KILMARNOCK FARM, CRAWLEY

Proposed Access

Stage 1 Road Safety Audit  
Requested by Motion

Document: Stage 1 Road Safety Audit

Figure 1: view from proposed access looking south

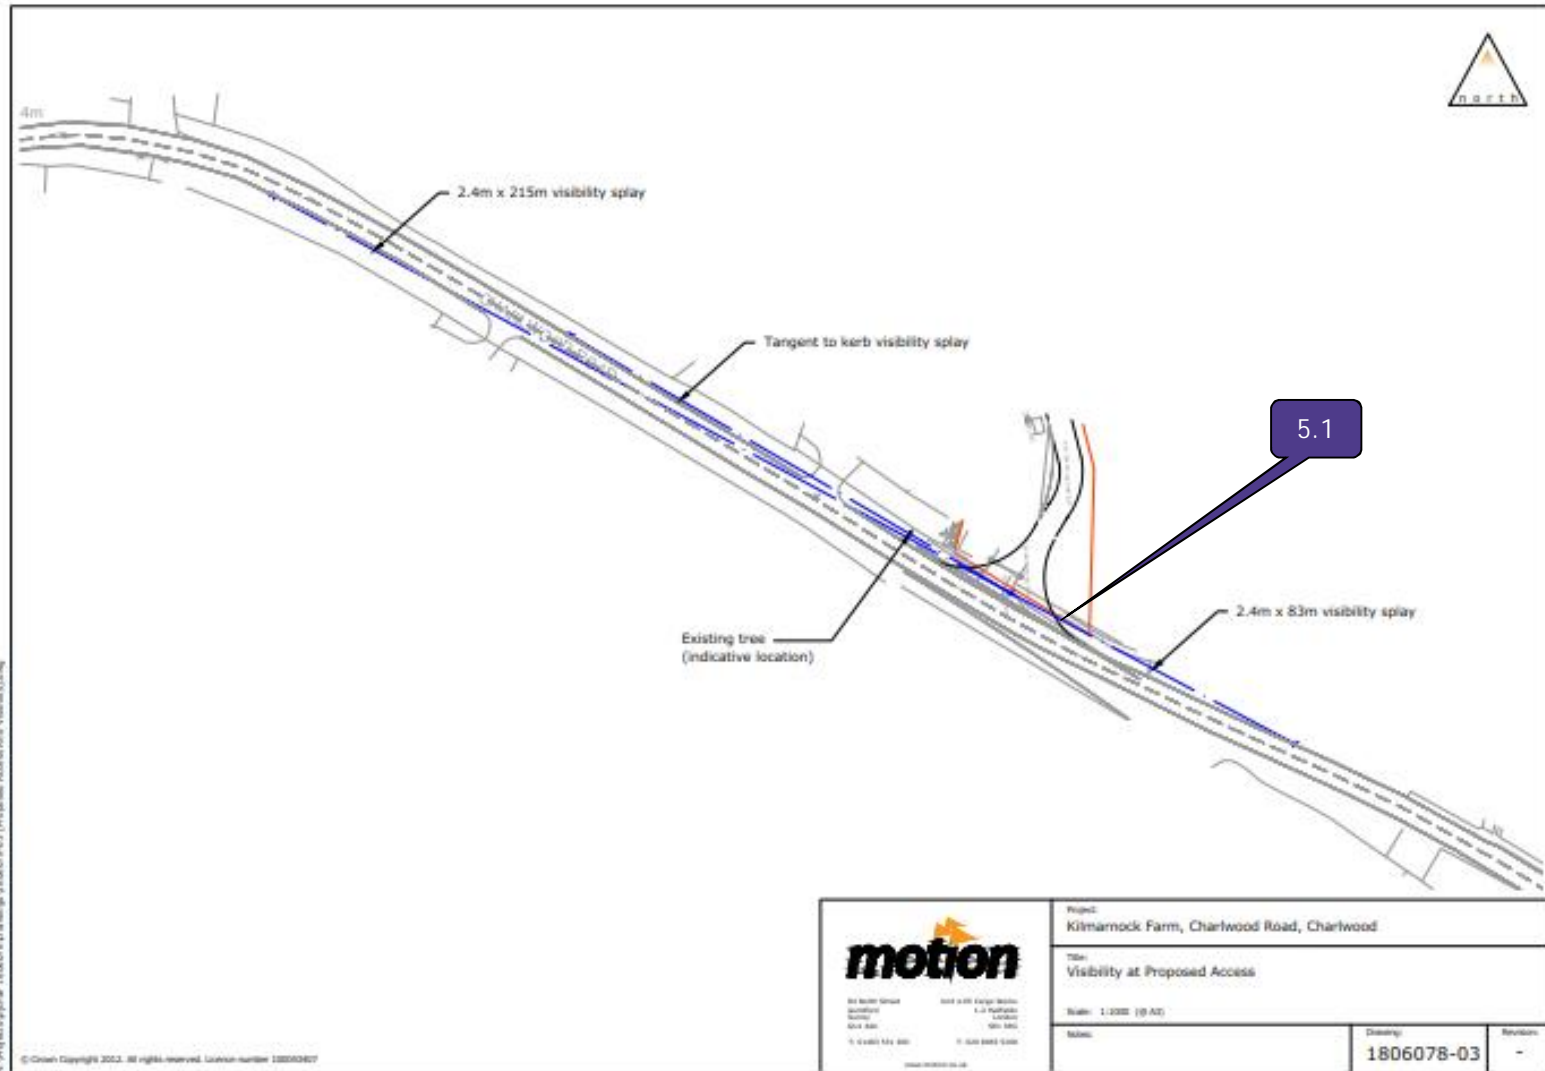
It is proposed to cut back vegetation to achieve the required visibility splays at the new access, however there is also a tree to the south, as shown in figure 1, and a telegraph pole to the north, which are not mentioned in the Transport Statement and which would obstruct visibility for drivers leading to nose to tail or t-bone collisions.

#### Recommendation

Obstructions such as trees and telegraph poles should be removed/relocated to achieve the required visibility splay.

Item No.	Audit Team Recommendation	Designer's Response	Audit Team's Further Comments
5.1	Obstructions such as trees and telegraph poles should be removed/relocated to achieve the required visibility splay.	A detailed review of the visibility splays was prepared as part of the initial junction analysis/design. Several trees have been identified for removal/trimming, and the implications of the telegraph pole to the north of the access has been identified. The telegraph pole is to be retained in its current location - there will be little impact on the visibility splay to the north. Full details are presented on Motion Drawing 1806078-04A.	Accepted.
5.2	n/a		
5.3	n/a		
5.4	n/a		
5.5	n/a
